AEROPRAKT

SERVICE BULLITEN

No. SB A-32-08

Model: A-32

Photo 1

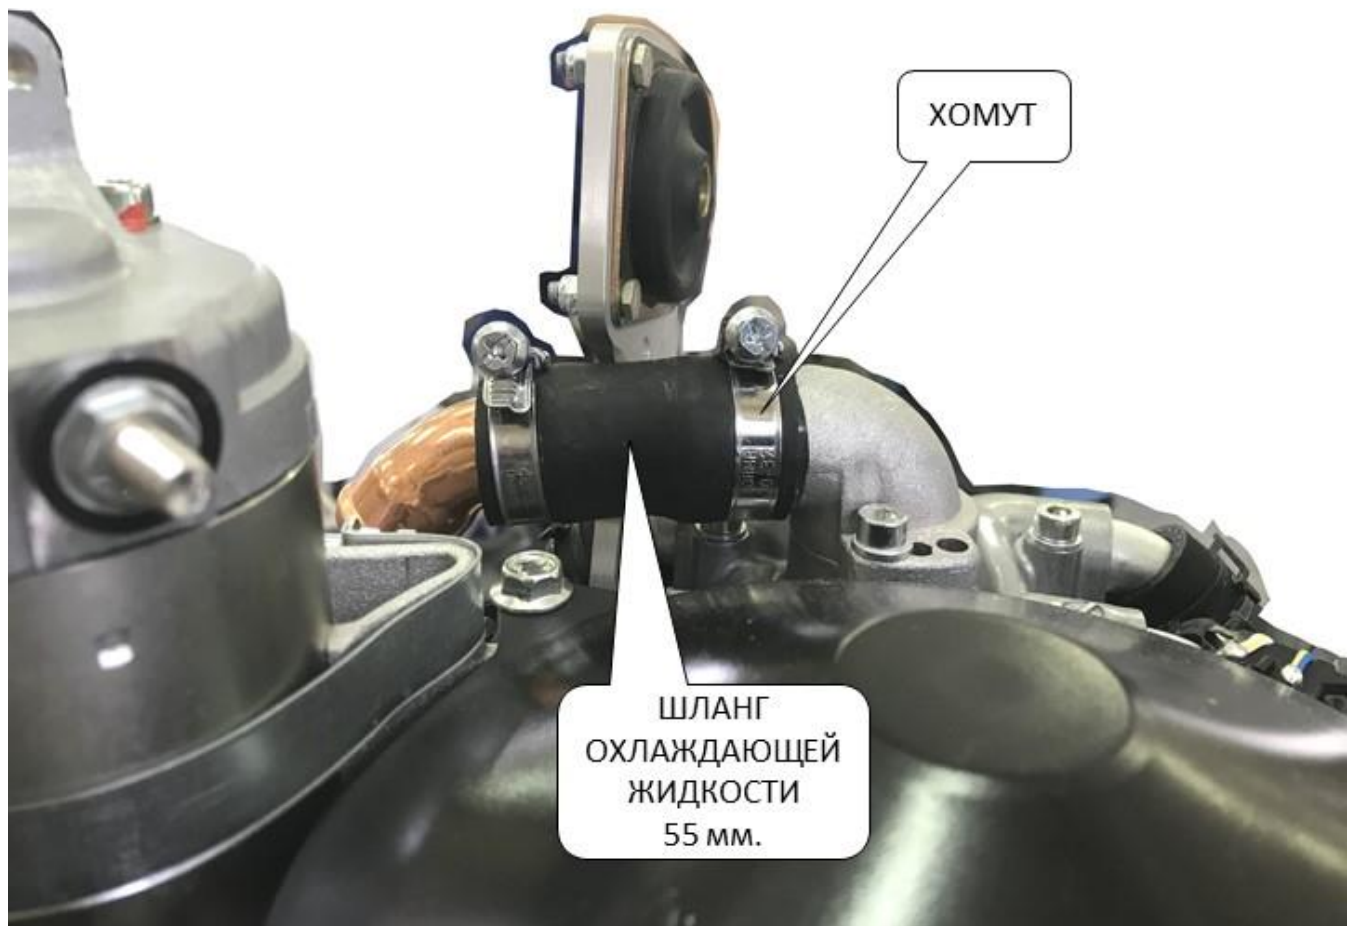
Cases of spontaneous disconnection of the coolant supply hose from the inlet pipe of the water pump (see Photo 1).

Screw-clamp attaching the water hose on the engine cooling system water pump inlet. See photo 1.

- in the “INSPECTION CHART” table add a line for the first inspection of the screw-clamp after 25 hours and every 100 hours for the following inspections;
- add instruction: “When inspecting the screw-clamp attaching the water hose to the water pump inlet make sure its tightening torque is equal to 4 N·m (3 lb·ft).

3.2) Tighten the screw-clamp shown in Photo 1 to 4 N·m (3 lb·ft) torque.
